Service Instruction

S.I. No.: 95-9-1

Title: CORNER STUD HOLES IN TCM CYLINDER BARREL FLANGES

Revision: 2 (12/21/01)

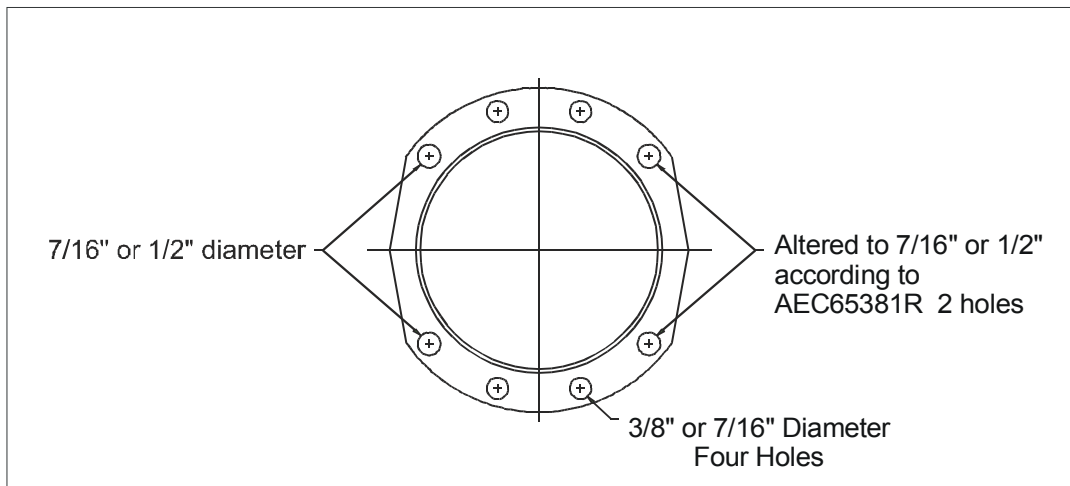
Engine Components, Inc. (ECi) has FAA Engineering Approval to drill 7/16 inch diameter flange corner stud holes to 1/2 inch diameter, and 3/8 inch diameter corner stud holes to 7/16 inch diameter for the TCM 360 series cylinders. This alteration facilitates the barrel installation after cylinder head heat treatment or the incorporation of the Cerminil™ process.

Testing has shown this alteration does not affect the installation of the cylinder on the crankcase or change the stud preload (stretch), strength or operating characteristics of the cylinder on the engine.

This alteration is reflected on Engine Components, Inc. drawing AEC631397 (new barrels), drawing AEC65381R (used barrels) and is documented and approved through EC Report 9408-2.
